**ZIONSVILLE PLAN COMMISSION MEETING RESULTS**  
**Tuesday, January 21, 2020**

**Petition Number:** 2019-52-Z

**Petition Number:** 2019-55-DP

**Site Exhibit**  
 HUB I-65 - Phase II  
 S.R. 267 and Indianapolis Road  
 Zionsville, Indiana 46075

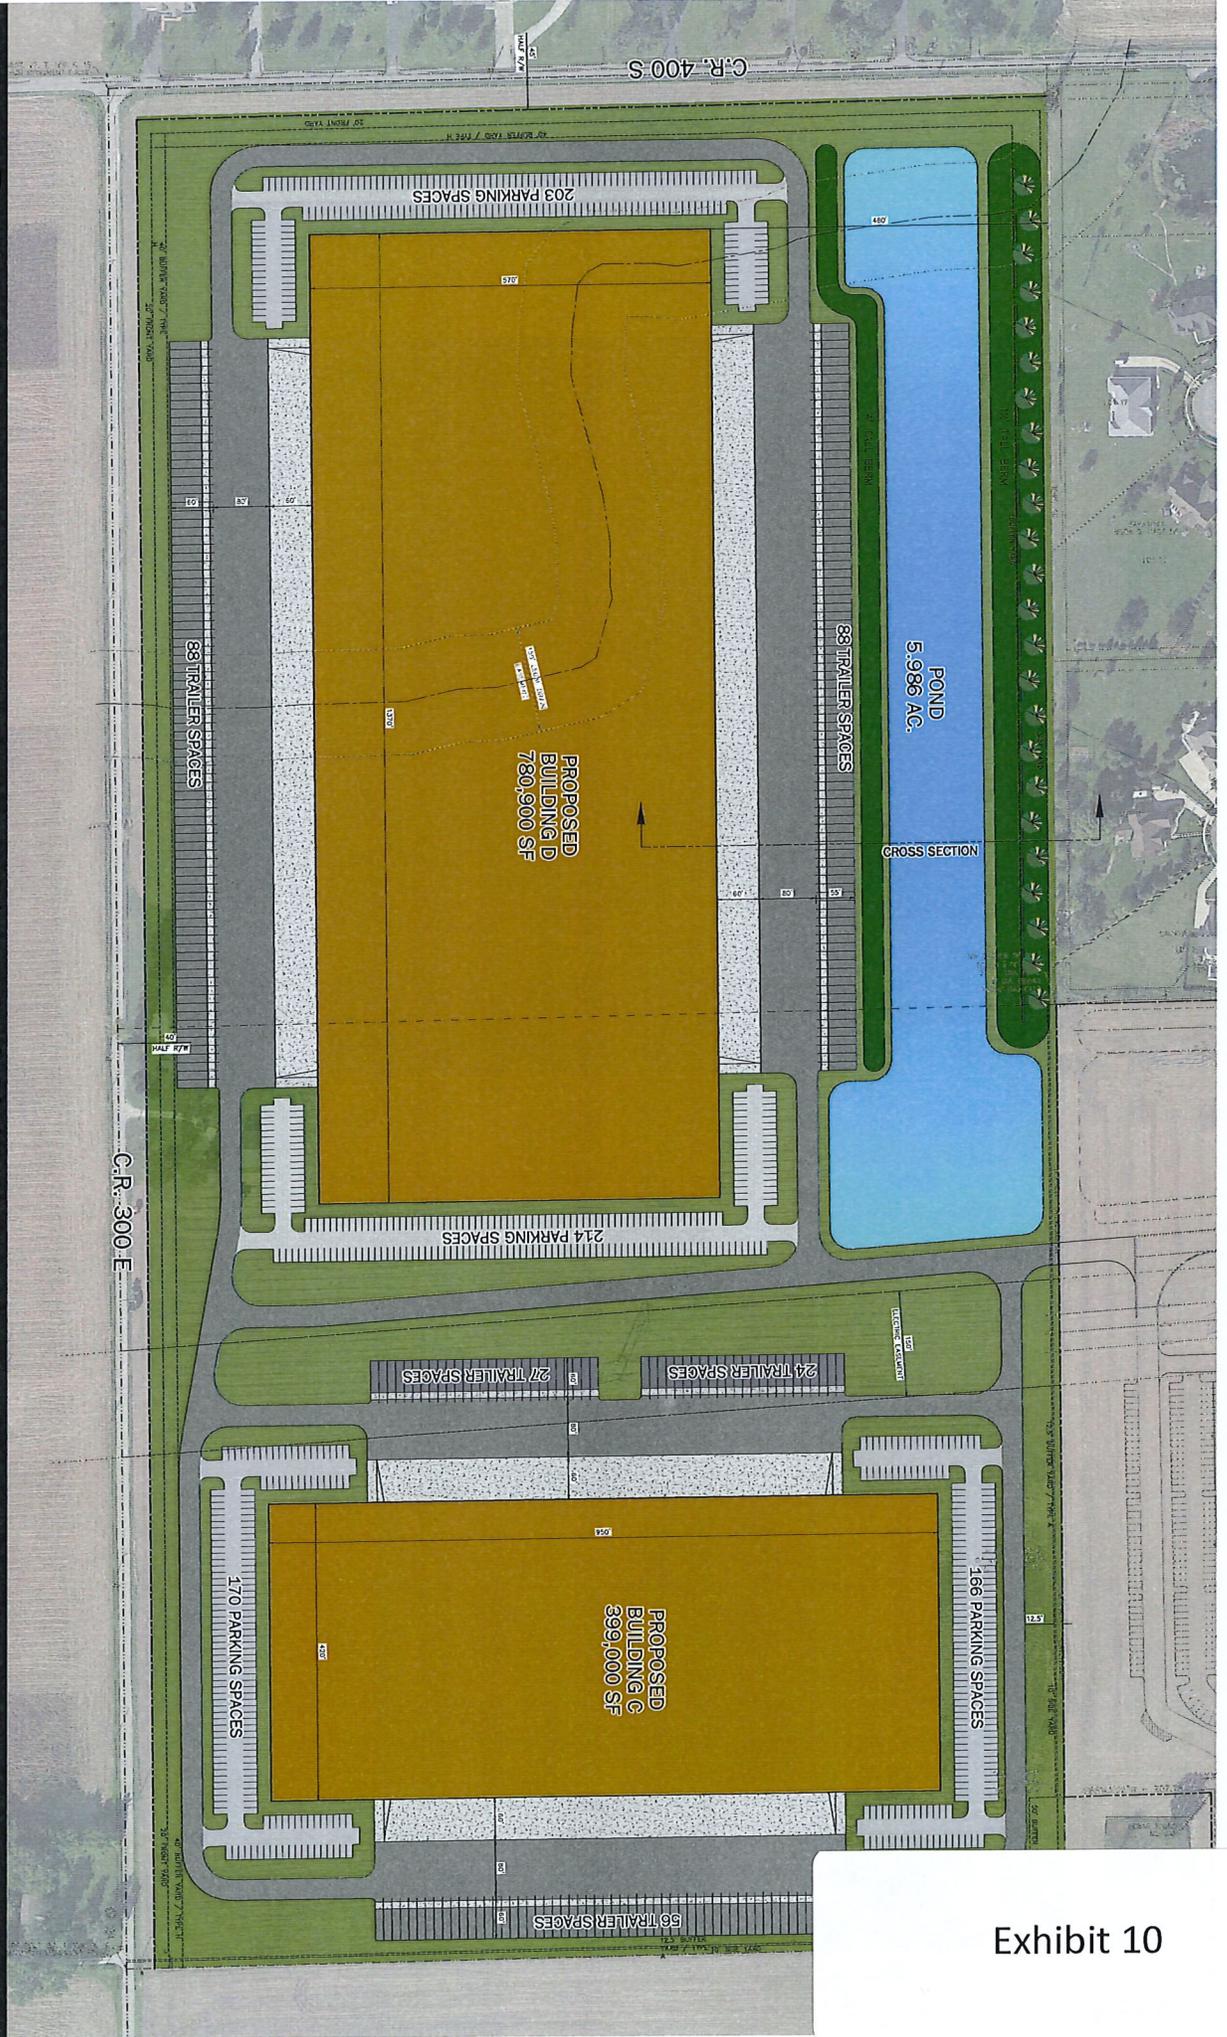
1. The berm width in the commitments (60 feet) does not match the berm width in the exhibit that was attached (75 feet).
2. The 10 foot greenspace around the pond should be 15 feet, which is the minimum easement required in the Stormwater Standards and the Town's desired distance around a pond for maintenance. The green space width should match the easement width for maintenance purposes. This should be confirmed.

3. Commitment number 8 references the site plan and states bufferyards. I recommend editing that statement to read: "The development of real estate shall comply with the bufferyard requirements for Rural development standards and process outlined in the Town's Zoning Code." The email we just received states the bufferyards won't be a part of the zoning petition, but the commitments presented in the package references the site plan and specifically references bufferyards.

4. Recommend a note that all dimensions and layouts are subject to final site design requirements.
